Service Technical Information

MODEL NO. NSX-S222 / S555 series
SUBJECT No compatibility between 4ZG-1 and AZG-1Z8

REF.No. :G - 99 - 050 - E0

DATE :02. NOV. 1999

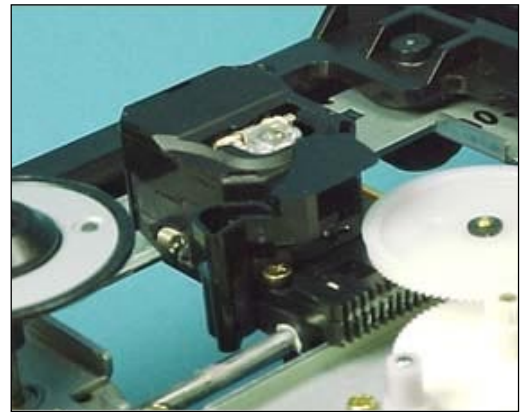
Two types of CD mechanisms, 4ZG-1 and AZG-1Z8, are used in NSX-S222 and S555 series products.

When repairing the products, note that pick-ups and microcomputers used in 4ZG-1 and AZG-1Z8 are not compatible with each other.

The pickups used in AZG-1Z8 (KSS-880) are supplied in chassis ASSY (KSM-880CAB). Replacement of the whole chassis ASSY is required to replace the pickup.
